ATTACHMENT A

124 HAIDA TRAIL

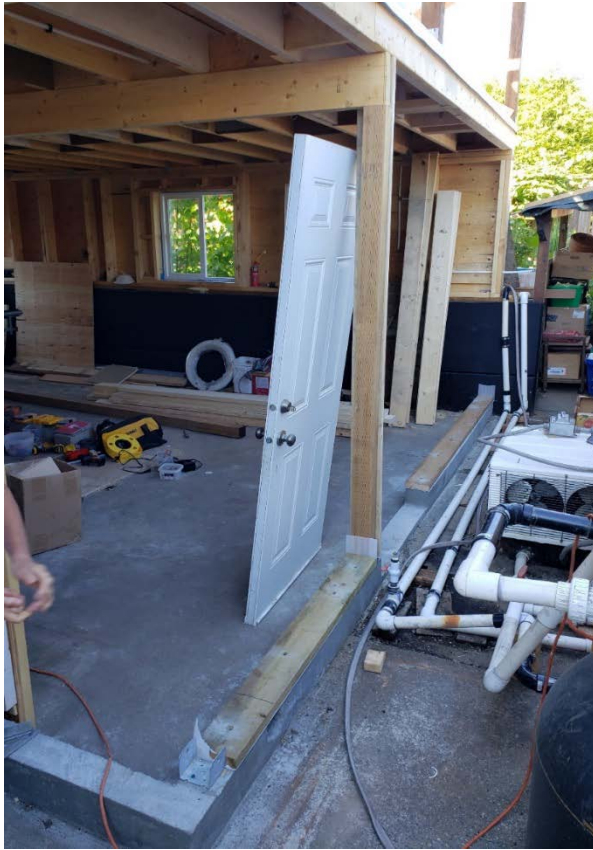
Concrete curb walls
bearing conditions
unknown.

New water lines
installed.

New framing to
expand existing
room, the step in the
concrete is visible by
the radio.
